Historic landscape advice relating to a proposed new Design Technology & Engineering (DTE) building for Stowe School (application reference 20/03822/APP)

23th August 2021

Figure 2.2: South east elevation of the proposed DTE building in the centre of the image behind Park Field House. West 5 Boarding house lies to the left and Lyttelton to the right (extract from Design Engine drawing 1617-P360 P01).

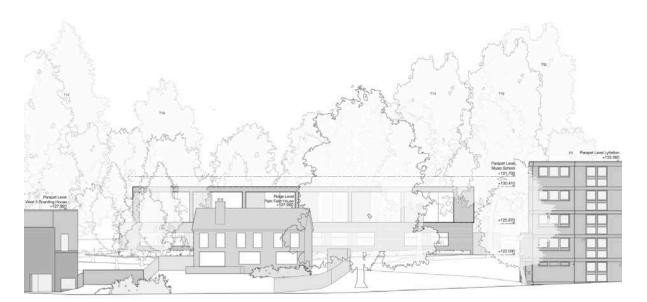
- 2.3 Plan dimensions are not provided on the submitted drawings, therefore approximate dimensions have been scaled from the drawings to ascertain the footprint of the proposed building. The main rectangular portion of the proposed building appears to be approximately 42m x and 13.2m in plan. The dimensions of the building at its largest extents including the heat pump enclosure and external stairway are approximately 47m x 18m including the single storey section of the building with external terrace/gallery.
- 2.4 Spot heights are noted on the elevation drawings enabling calculation of the building height which is 8.38m.
